Titan Actuator Wiring

PRODUCT: Titan 912 and 912L actuators

DATE: 05/27/2021

SUBJECT: Titan actuator wiring.

Fig-1: INCORRECT WIRING!

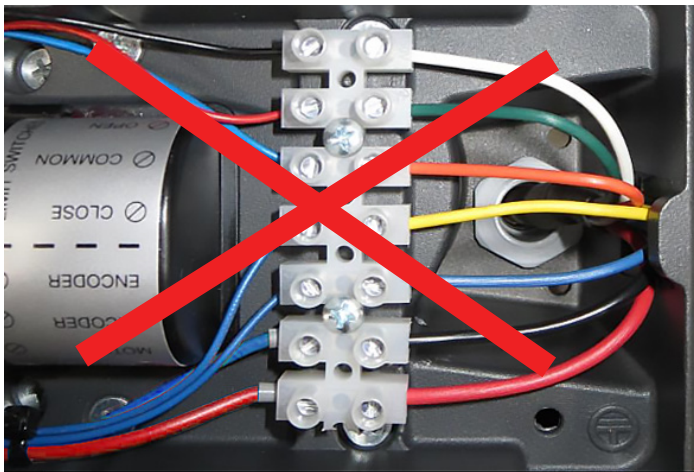
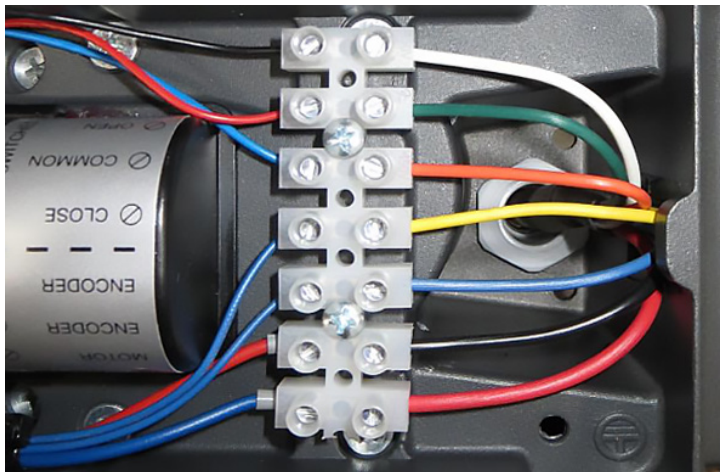
We have discovered that some TITAN actuators manufactured in 2021, and shipped from our facility after May 10, 2021, have the motor and/or limit wires reversed. This causes the motor to operate in the wrong direction with regards to the limits and instruction manuals.

Correct the wiring on the terminal block that can be found near the limit adjust wheels. See Fig-1 and Fig-2 for examples of incorrect and correct wiring. Or you may return the actuator to Nice | HySecurity for a replacement.
